From: drainage <drainage@midsussex.gov.uk>
Sent: 20 December 2024 17:26:07 UTC+00:00
To: "Anna Tidey" <anna.tidey@midsussex.gov.uk>
Cc: "drainage" <drainage@midsussex.gov.uk>
Subject: 2024.12.20 Re: DM/24/2933 - App - Minor - 23 Meadow Drive Lindfield
Haywards Heath West Sussex RH16 2RS

Thank you for consulting the Flood Risk and Drainage Team with regard to the above application. We understand the application is for demolition of existing garage and erection of a two storey rear and side extension and new front porch. The Flood Risk Assessment provided by the Applicant has been reviewed, and we would comment as follows:

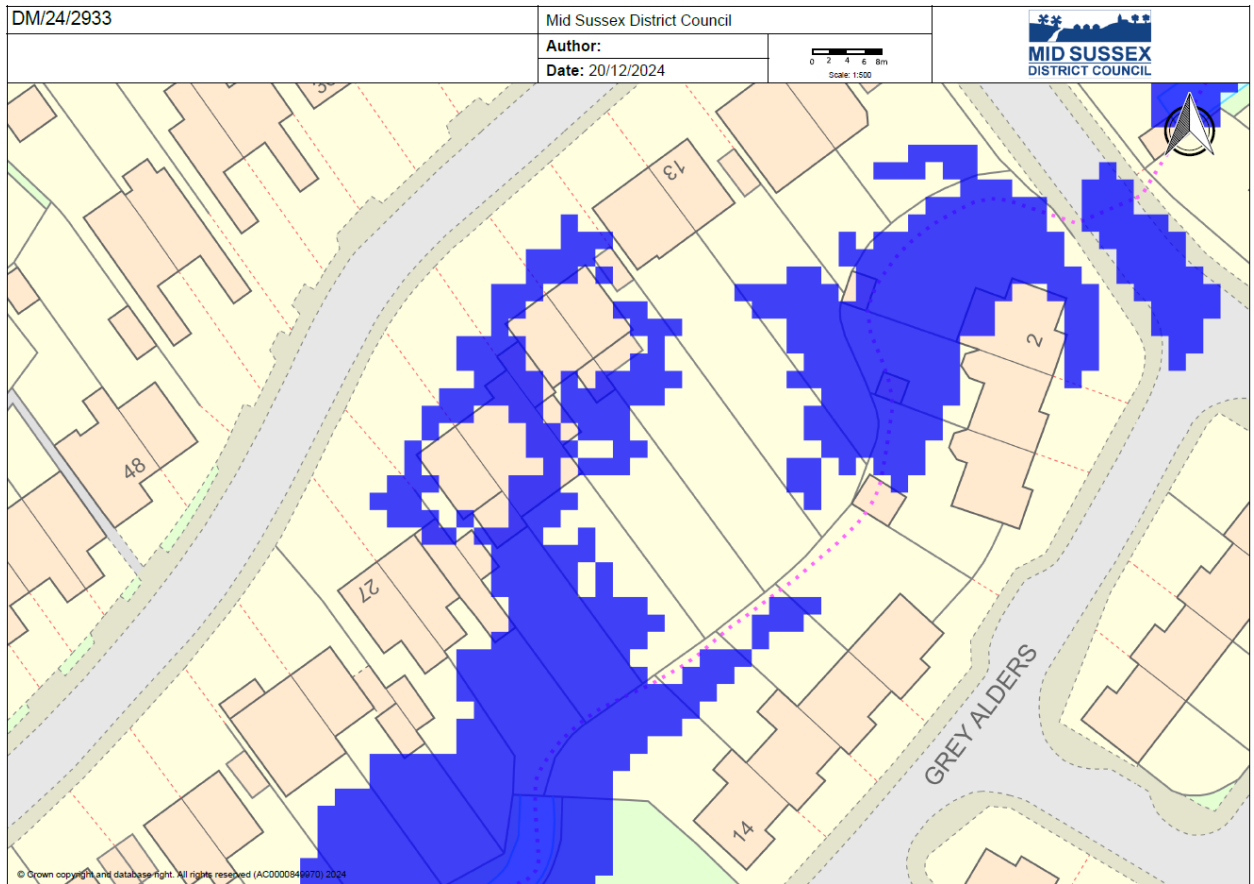
The site is in flood zone 1 and is at low fluvial flood risk (risk of flooding from Main Rivers). The site is shown to be at very low, low, medium, and high surface water flood risk (comparable to flood zone 3b, 3a, 2 and 1).

The proposed development site is located within an area impacted by the 1:30, 1:100 and 1:1,000 flood events (high, medium, and low surface water flood risk). Following the approach set out under the NPPF for assessing fluvial flood risk (flood zones) this area would be considered consistent with Flood Zone 3b (1:30 extent), Flood Zone 3a (1:100 extent), and Flood Zone 2 (1:1000 extent).

Based on the latest guidance that all sources of flooding should be considered consistently the site meets one of the reasons an area would be considered functional floodplain (Flood Zone 3b); it's location within the 1:30 surface water flood extent.

It is the Flood Risk and Drainage Team's findings that, following the latest guidance on assessing flood risk the site is located within the equivalent of Flood Zone 3b (1:30 flood extent) and the proposed development is a more vulnerable development.

As per the Environment Agency standing advice for minor extensions, development within the 1:30 flood extent is not permissible. In the event that the proposal is outside of this extent then additional resistance and resilience mitigation will need to be evidenced at this location, as this development is classified as 'more vulnerable'

In addition, the Flood and Drainage Team would have no objection to the scheme if surface water modelling can be provided which demonstrates that the development design ensures that, for the 1:100 year + climate change event:

- Site users are safe in the event of a flood
- There is no loss of floodplain storage
- There is no impedance of overland flows
- There is no increase in flood risk
